**REACTOR VESSEL MATERIAL SURVEILLANCE
PROGRAM FOR INDIAN POINT UNIT NO. 2
ANALYSIS OF CAPSULE V**

**FINAL REPORT
SwRI Project No. 17-2108
(Revised)**

March 1990

SKETCH 1

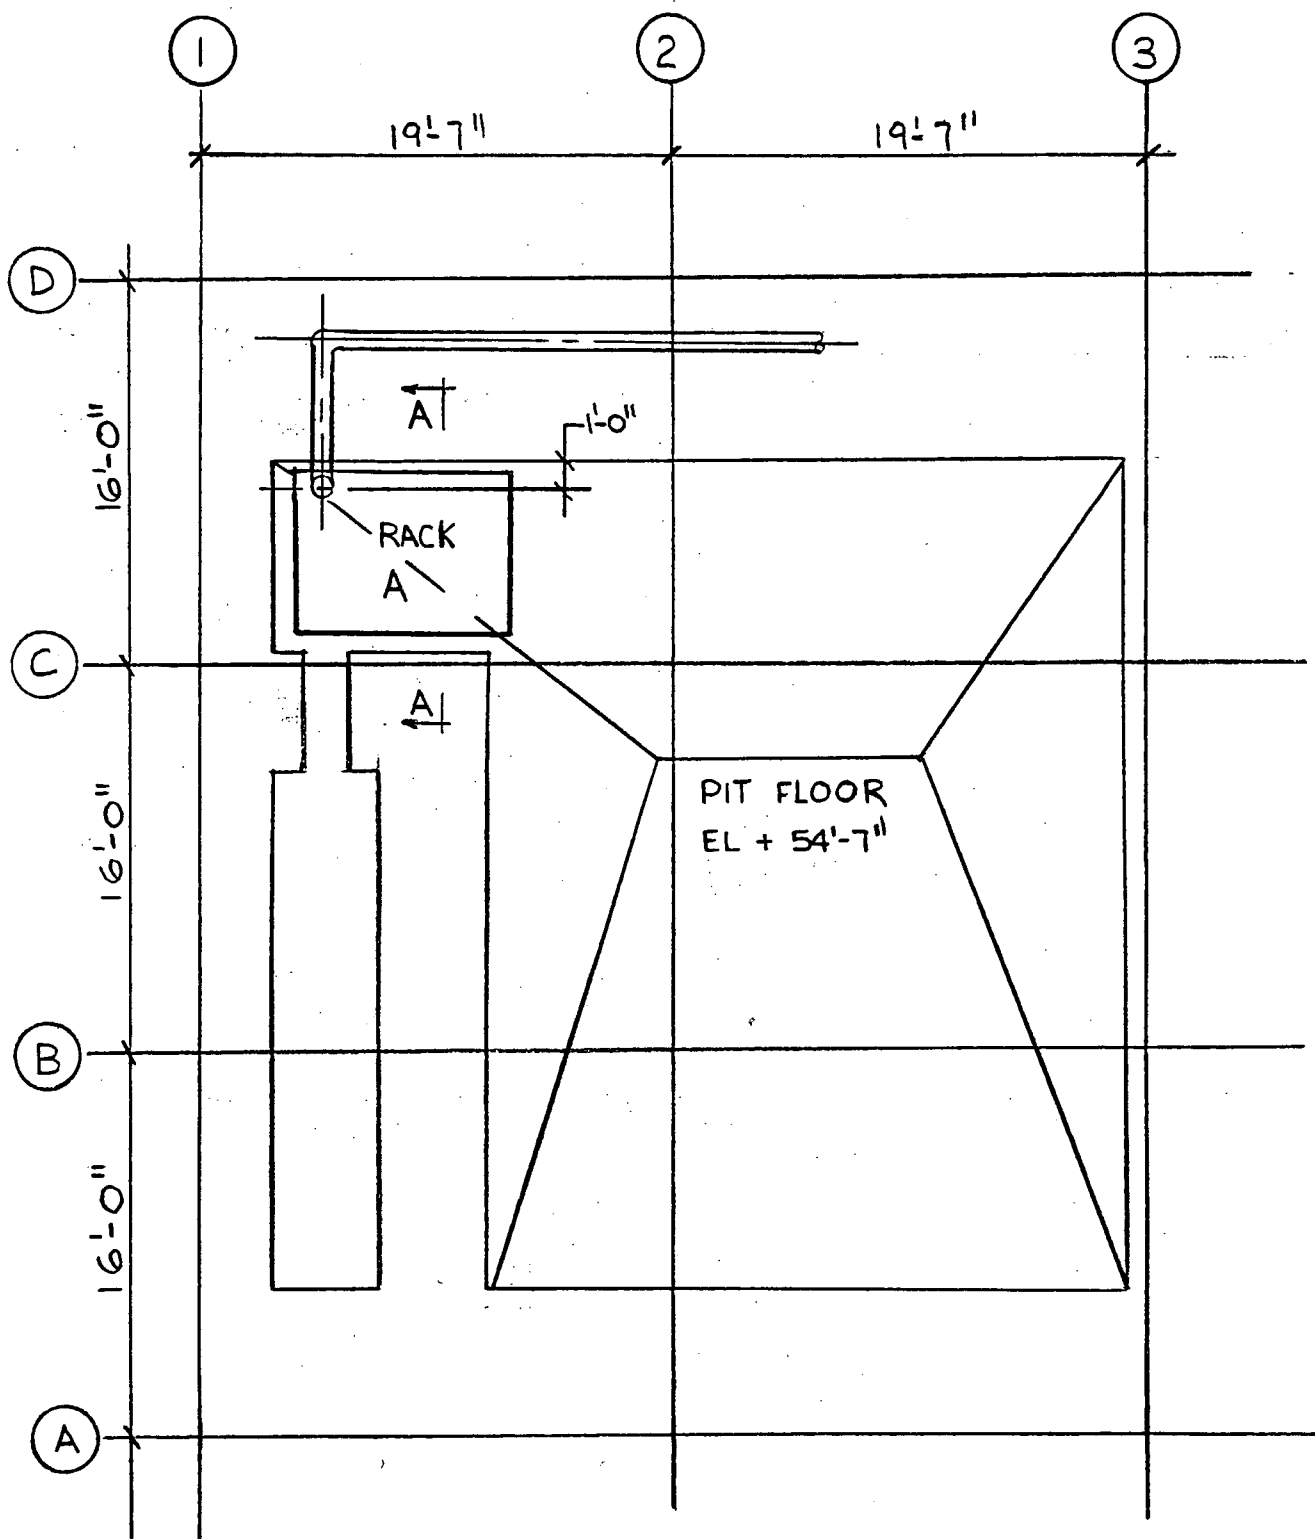
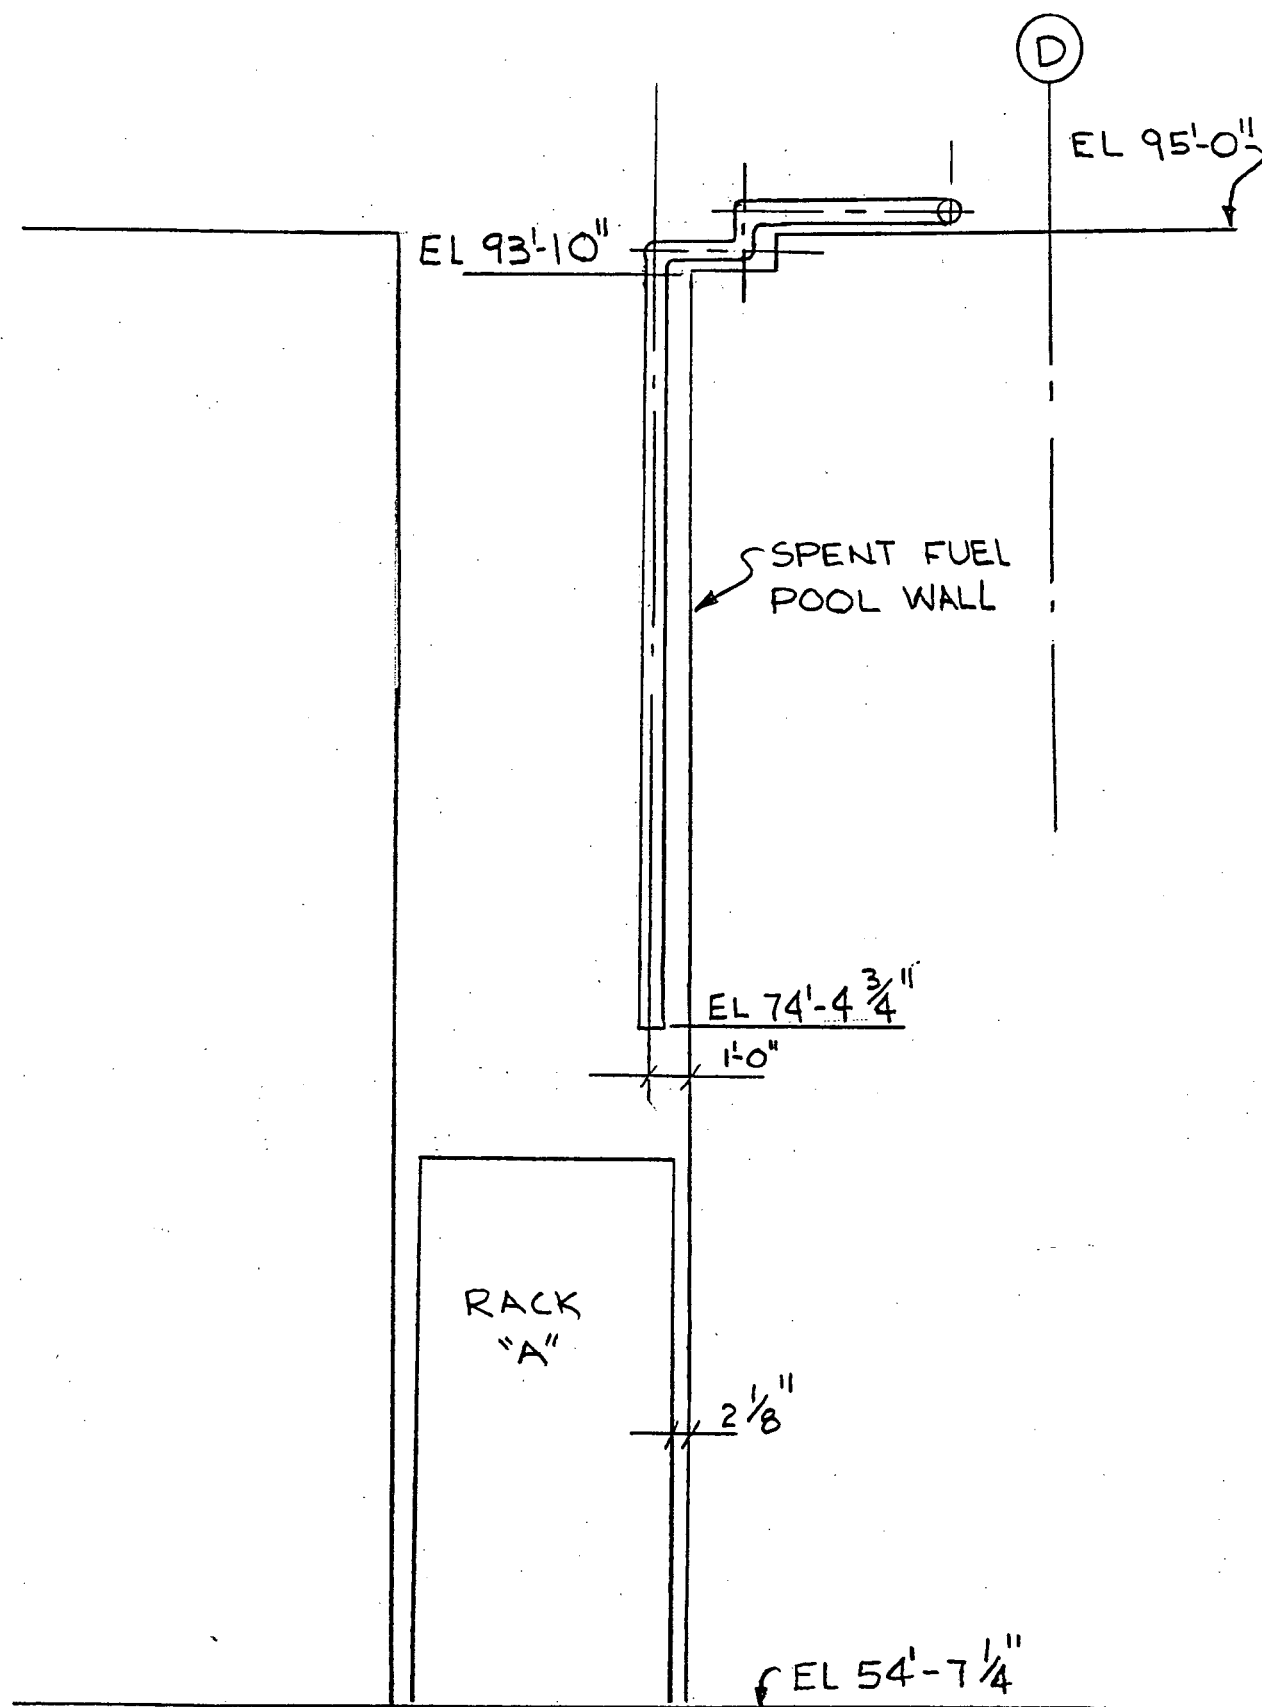
1. Provide sketches and/or drawings of the pool showing elevations, basemat and pool wall thicknesses, water levels, and safety related components (such as piping in the pool, and their clearances from the racks.

The following sketches and drawings are provided in response to the above request:

The drawings listed above show the pool elevations, basemat and pool wall thicknesses. Drawing 9321-F-2514 shows the pool water level in the section of the drawing labeled 'Elevation @ Section "A-A"'. The water level given is the normal water level, 93'8", and can vary during operation by $\pm 6"$. Sketch 1 provides an overview of the spent fuel pool indicating the location of the portion of the spent fuel pool cooling piping located in the pool. Sketch 2 provides the details of the clearance between this pipe and the rack below it. This section of pipe is the only safety-related equipment, except for the storage racks, in the spent fuel pool.
